November 17, 2017

SUBJECT: NuScale Power, LLC Submittal of Changes to Final Safety Analysis Report,
Section 8.4

“Changes to NuScale Final Safety Analysis Report Sections 8.4”

Figure 8.4-1: Station Blackout Reactor Pressure Vessel Water Level Above Top of Active Fuel

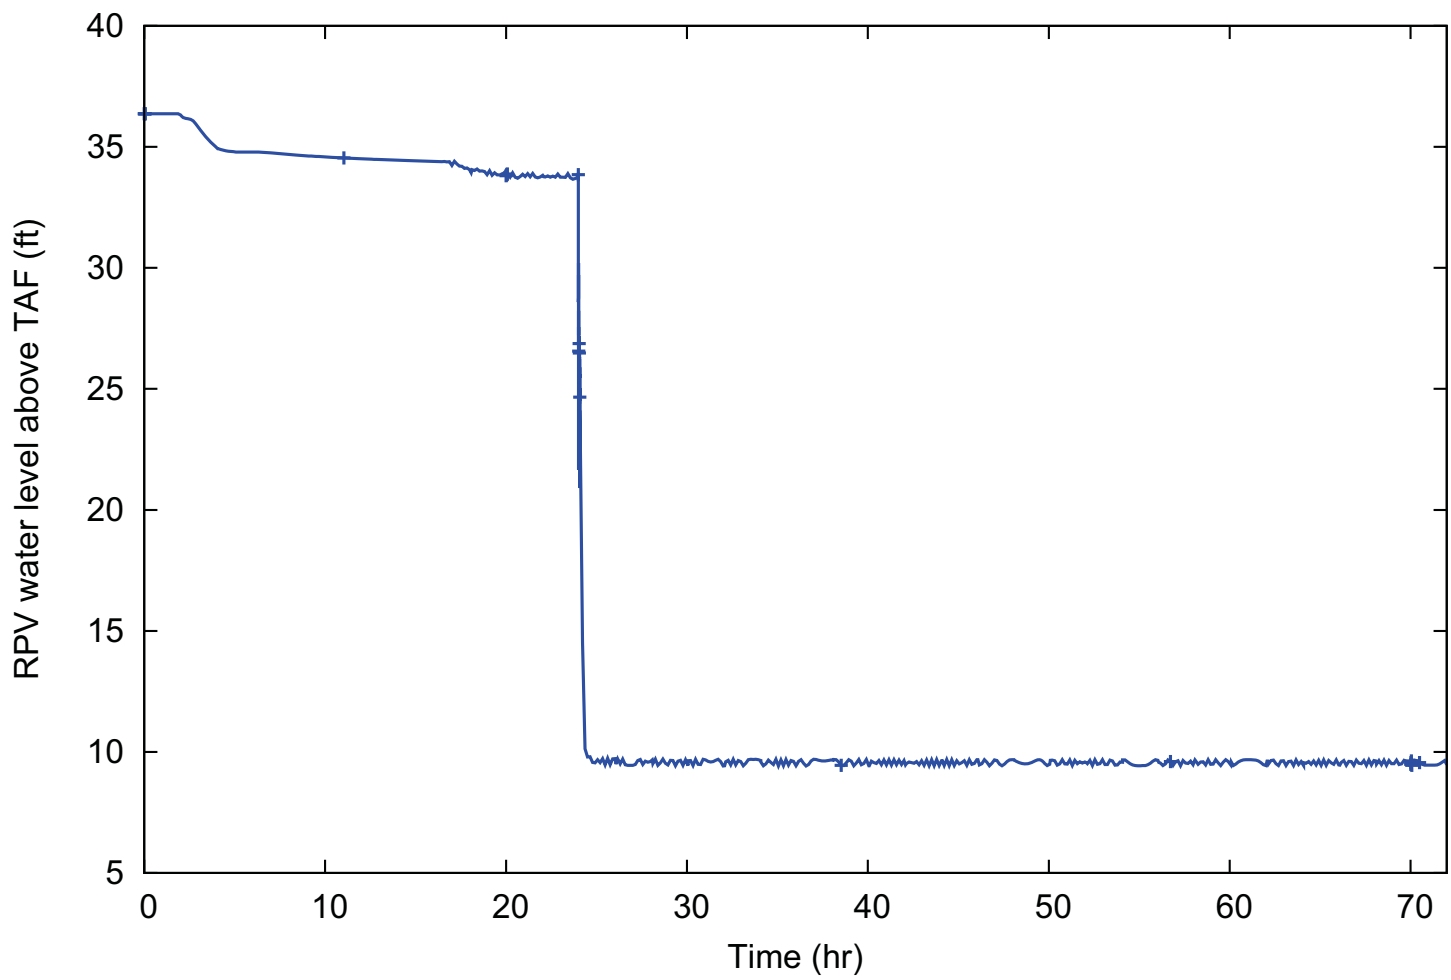
Within one minute, the DHRS begins to transfer heat from the reactor to the reactor pool and continues to operate for the event duration. ~~Under DHRS cooling, the reactor coolant system pressure and temperature continually decrease.~~ After 24 hours, the MPS actuates the emergency core cooling system (ECCS), and the ECCS vent and recirculation valves automatically open. At this point, ~~T~~he pressure and water level in the reactor pressure vessel (RPV) ~~rapidly~~ decrease, and containment vessel (CNV) pressure rapidly increases until equilibrium is reached. The DHRS cooling then declines in favor of cooling through the CNV wall via reactor coolant that circulates through the CNV. Stable cooling continues to the end of the transient, with a continued slow decrease in the temperature and pressure in the RPV and CNV. The water level in the RPV remains stable at more than ~~10~~⁹ feet above the top of the active fuel.
